**SAN ANTONIO WATER SYSTEM
CENTRAL SEWERSHED PACKAGE 3**

**SAWS Job No. 17-4528
SAWS Solicitation No. CO-00139**

**ADDENDUM NO. 1
September 27, 2017**

SUMMARY OF QUANTITIES

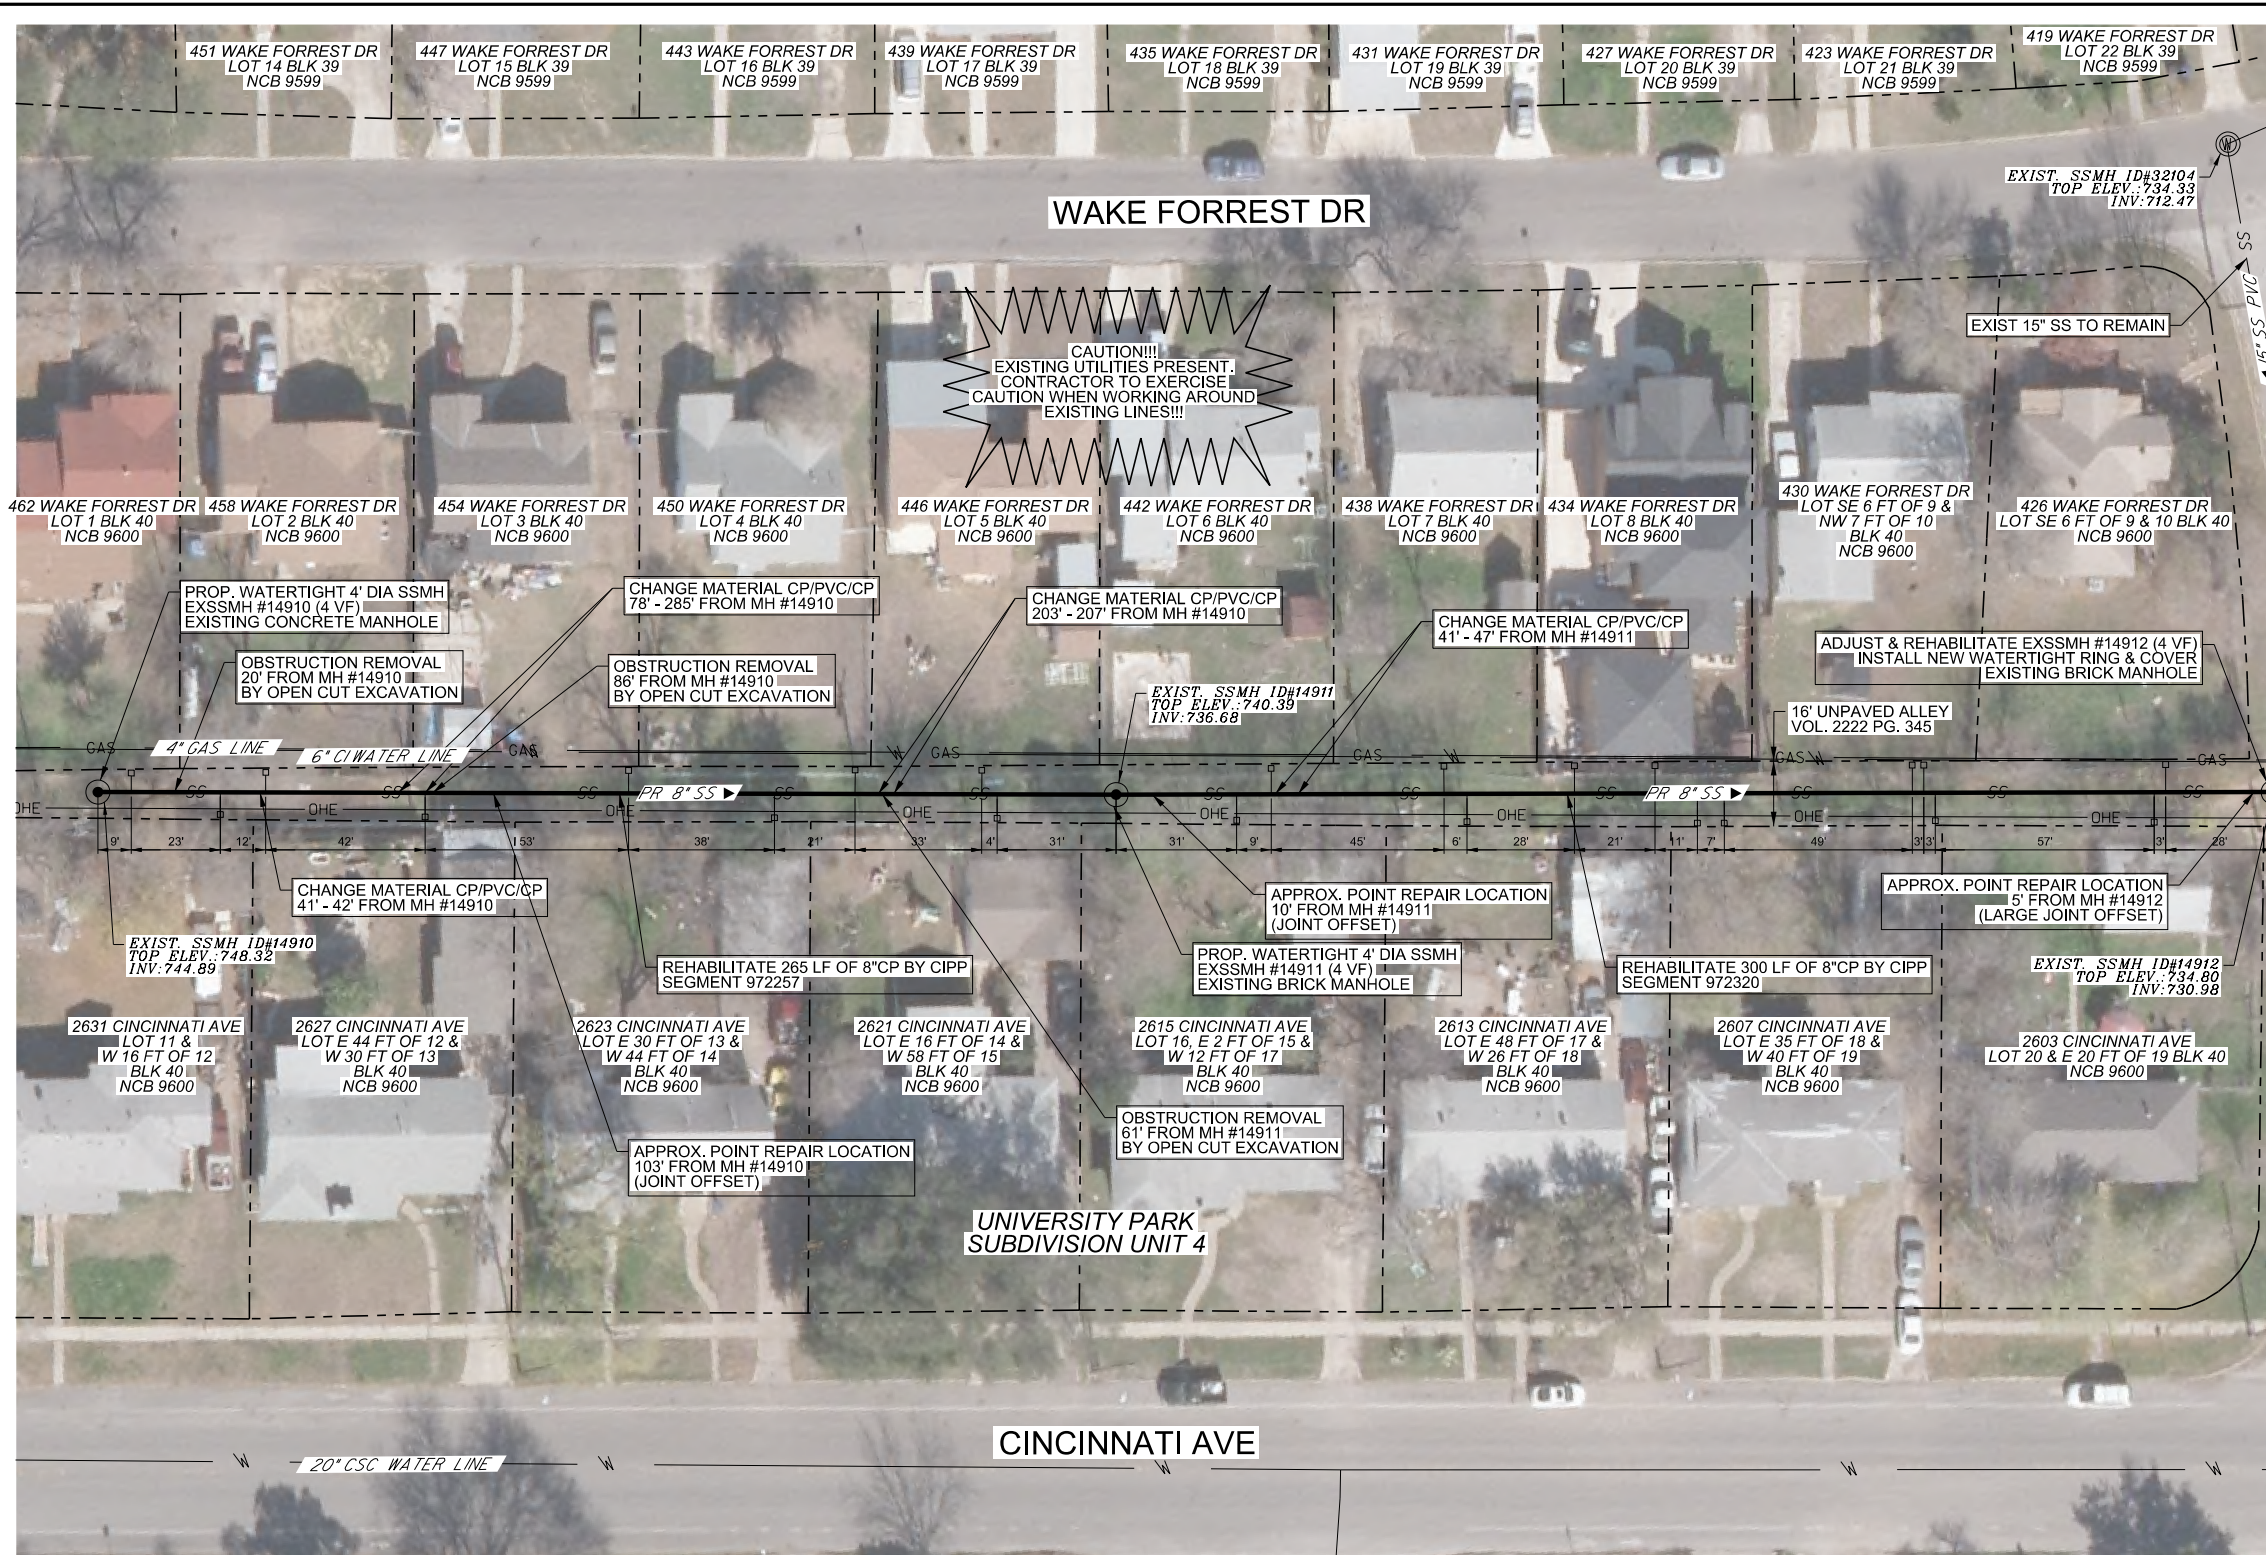
1. Remove Sheet 3 in its entirety and replace with the attached Sheet 3.
2. Insert Sheet 70 which was missing when the plans were originally released and is attached to this Addendum.
3. There are two Sheet 71's in the Plan Set. Omit the 2nd Plan Sheet 71 which shows (4) Item Descriptions in the Quantities Table. The 1st Plan Sheet 71 showing (5) Item Descriptions in the Quantities Table should be used when submitting a bid proposal for this project.
